**ADDENDUM #3**

**ITB# 2022-001**

**PROJECT: NORTH BAY VILLAGE BAYWALK PLAZA AREA NORTH - PHASE 1**

**DATE: 06/16/2022**

FINAL PLANS FOR REVIEW  
**STRUCTURAL DETAILS**

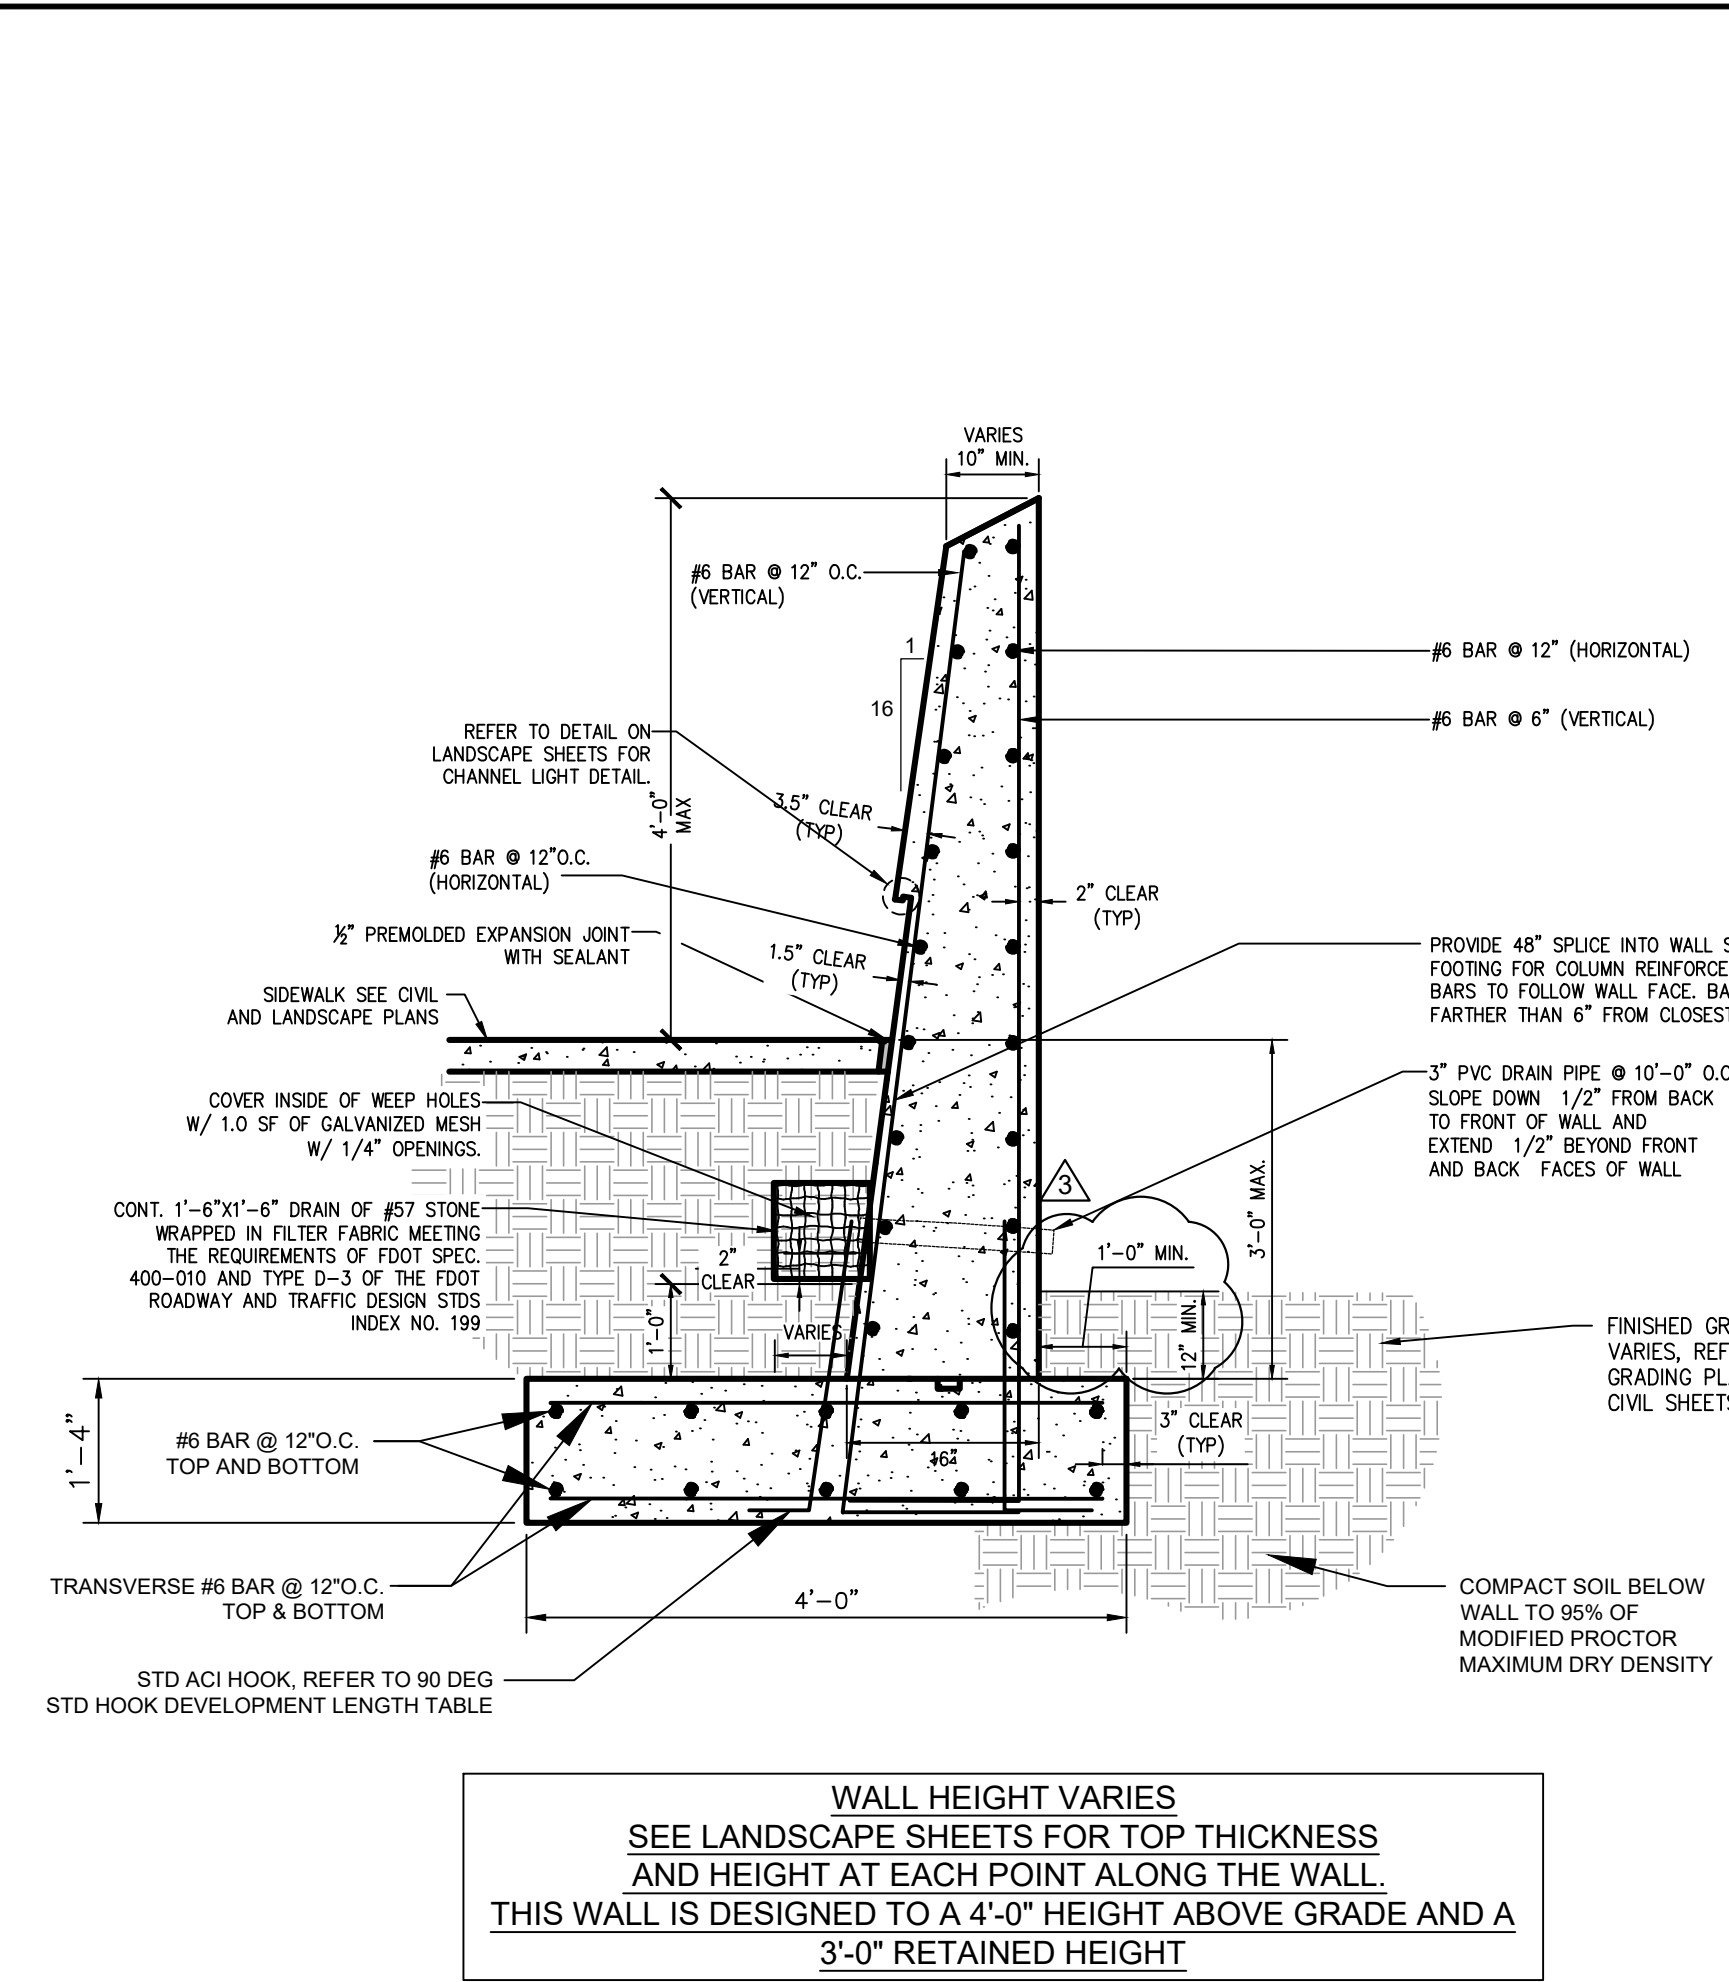
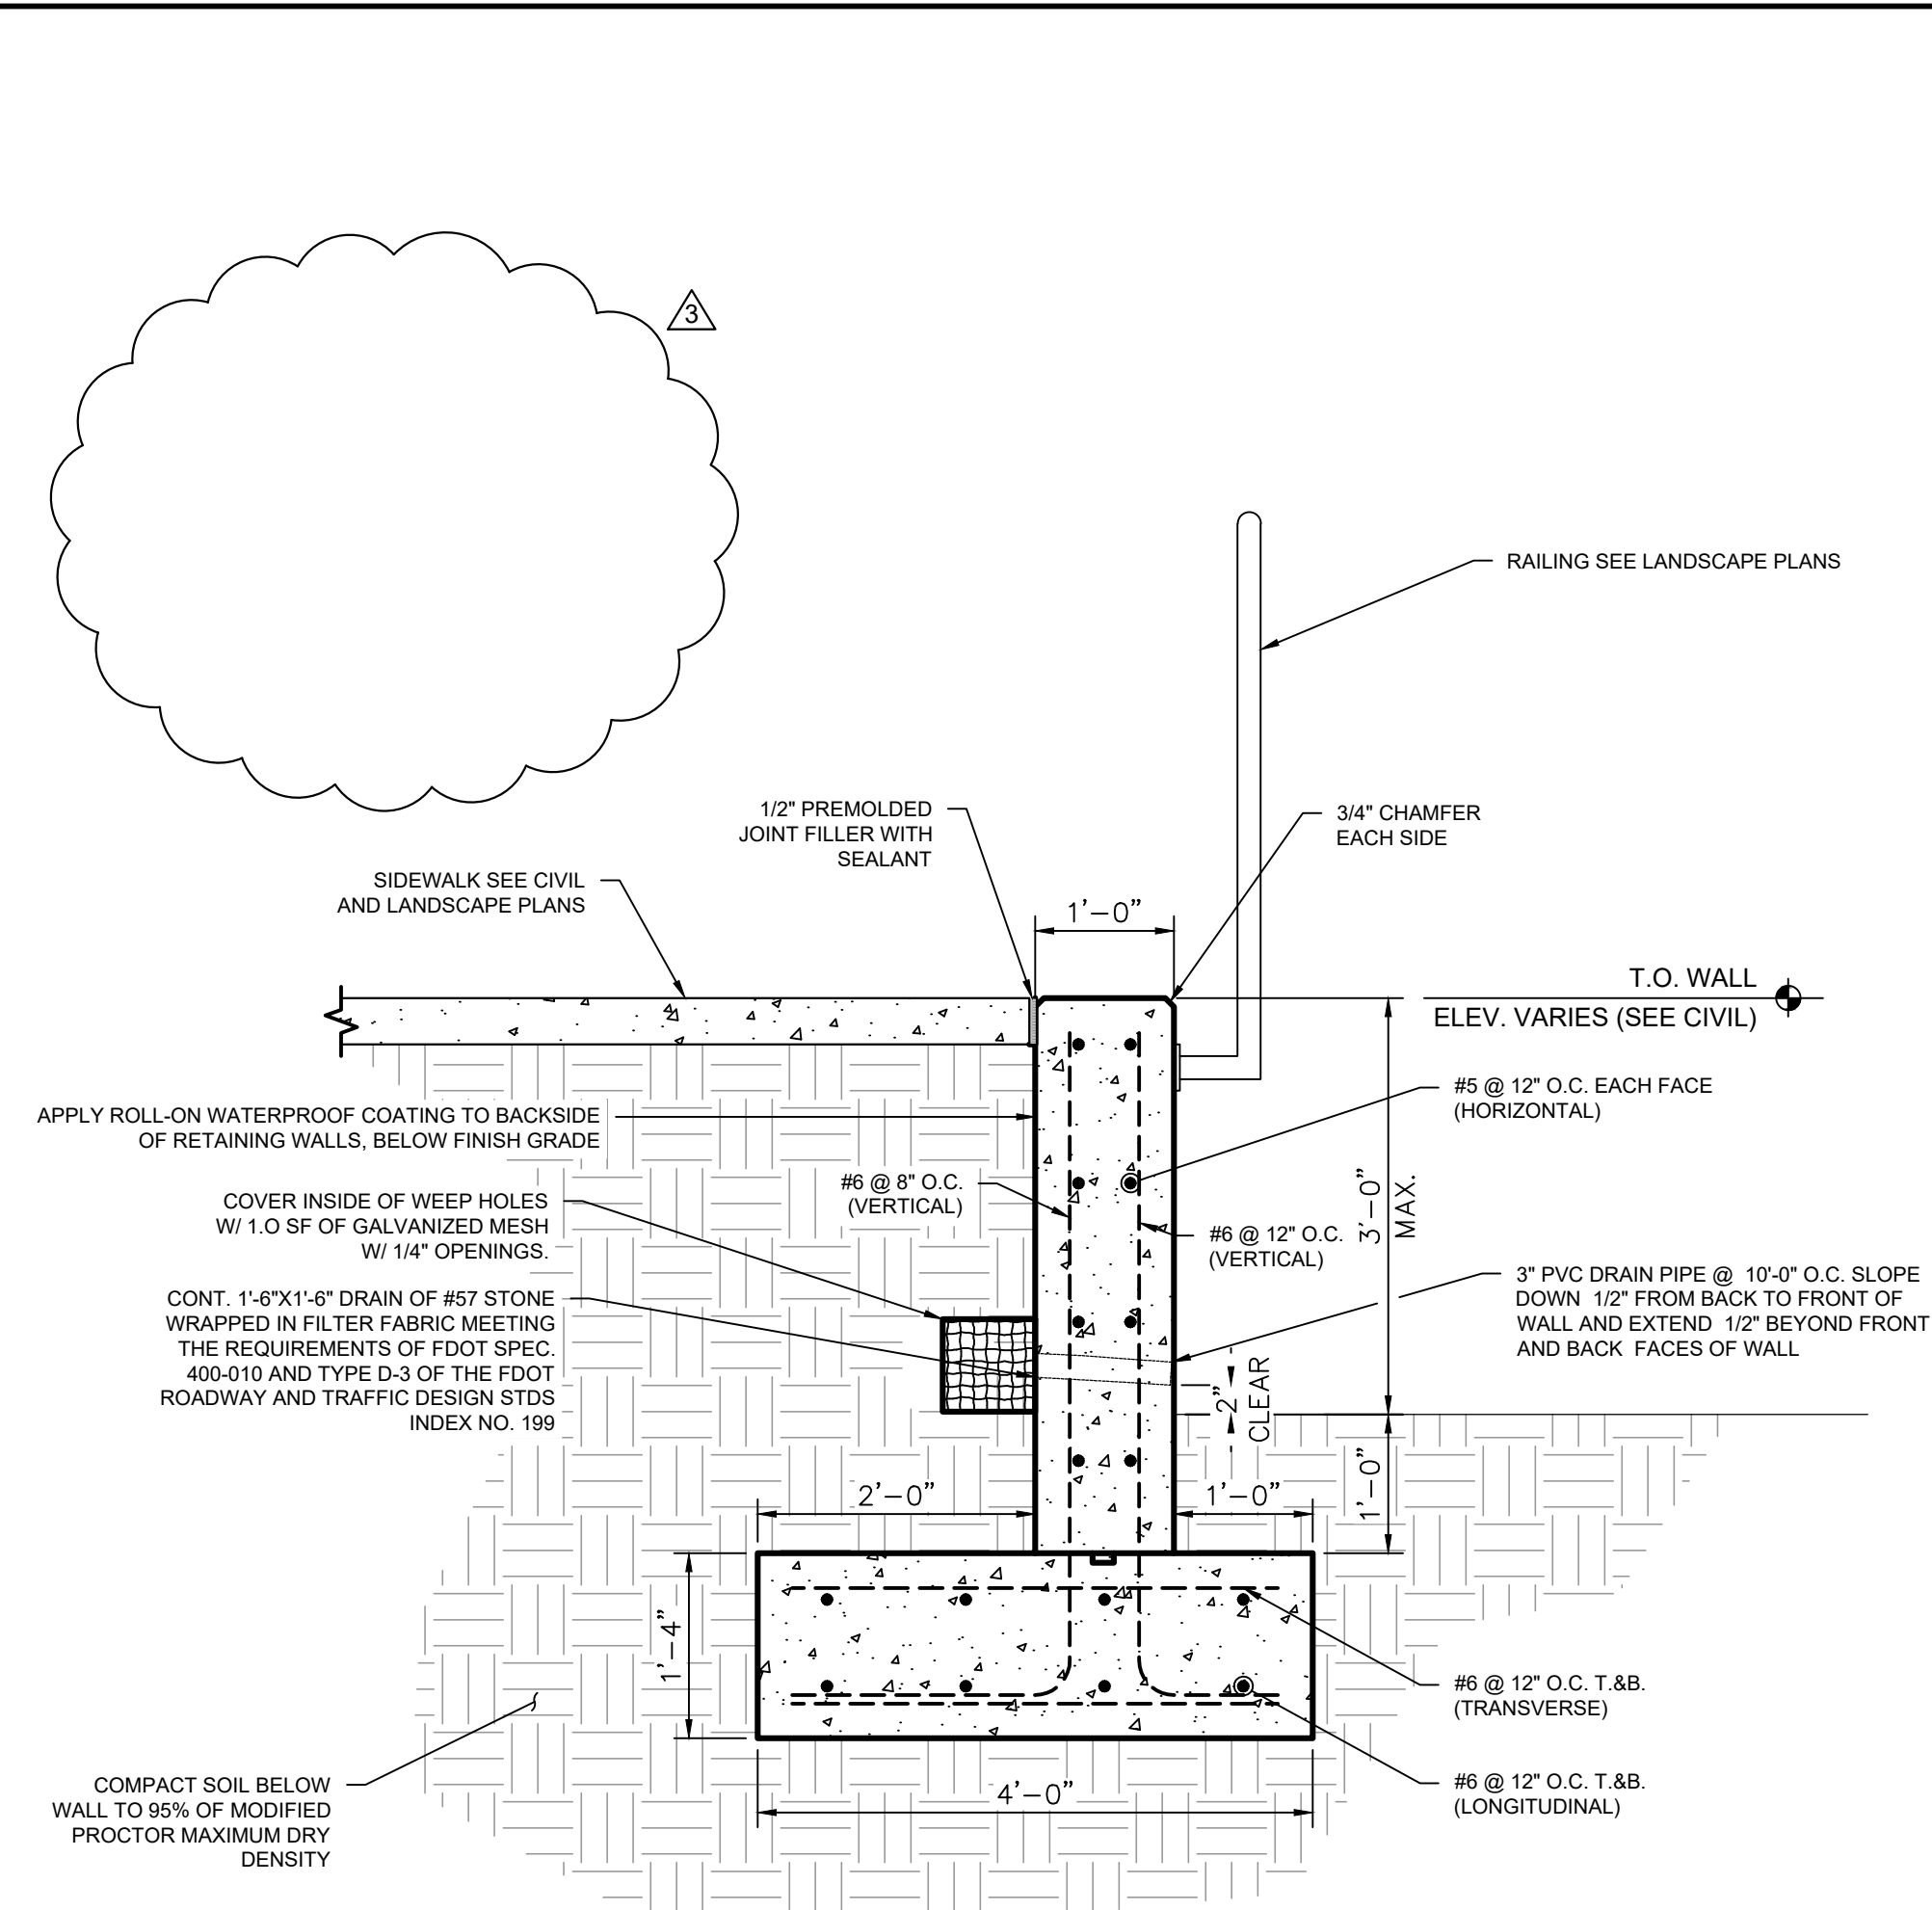
- **Attachment B – S-101 Structural Detail (Baywalk Plaza)** Replace with original set that says “Wellington Trace Traffic Calming for Town of Wellington” in the Title Block. Replace with correct sheet attached showing Baywalk Plaza North in the title block like other sheets of the bid plan set.
- **Plan Sheet L-352** - The North Pylon Monument Sign indicated in Plan Sheet L-352 indicates the name shown as “Baywalk Plaza”. This sign name has changed and is now “Island Walk Plaza “.

Revised S-101 sheet issued with Addendum No.3 for ITB2022-001 (revised 6/8/2022)
